Responses to Comments on Draft Initial Study/Negative Declaration

Street Lights Fullerton Project

October 2021

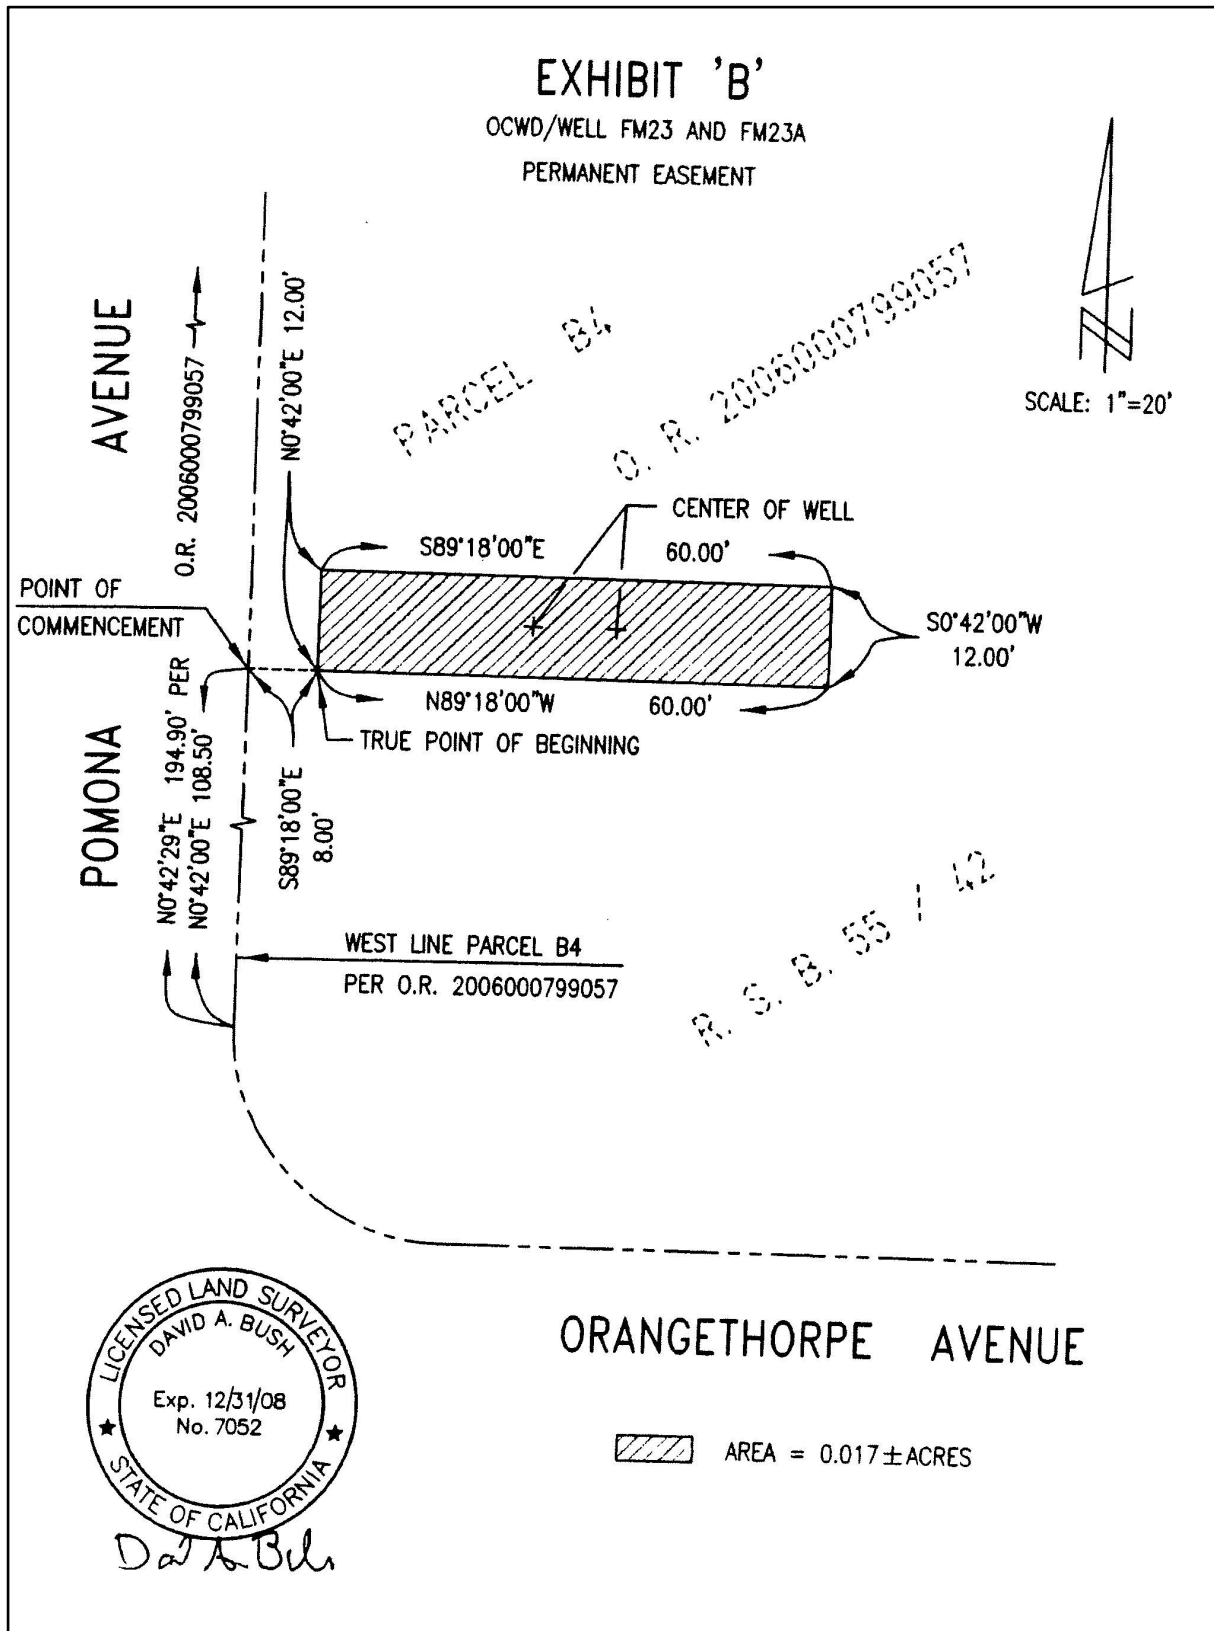
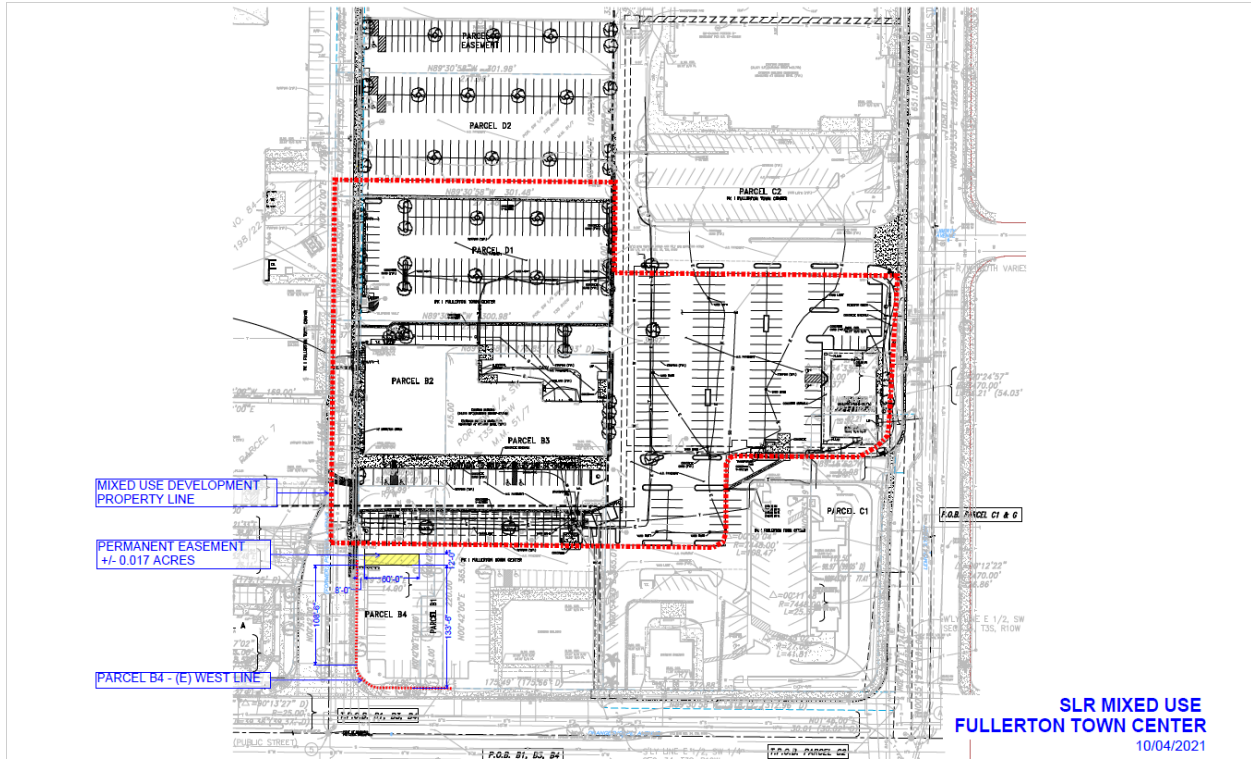
The District would also like to take the opportunity to notify the City of Fullerton that OCWD has permanent and temporary work area easements for two monitoring wells located within the properties to be developed (Appendix 1). These wells are identified as FM-23 and FM-23A. The Street Lights Fullerton Project must consider and evaluate impacts to OCWD easements.

OCWD-3 The comment notifies the City that OCWD's permanent and temporary work area easements for two monitoring wells (FM-23 and FM-23A) may be located within the Project site, and that the potential impacts to the easements should be considered and evaluated.

Following review of the easement documents, it was confirmed that the temporary work easement for construction has terminated. With respect to the permanent easement, identified on "Exhibit B" provided below, the 12-foot easement begins 108.50 feet from the point of tangency (PT) of Orangethorpe Avenue and Pomona Avenue and ends 120.5 feet from the PT. As seen on Project Easement Exhibit, the easement completely lies south of the proposed Project.

Therefore, location of the proposed Project would not conflict with OCWD's permanent and temporary work area easements.
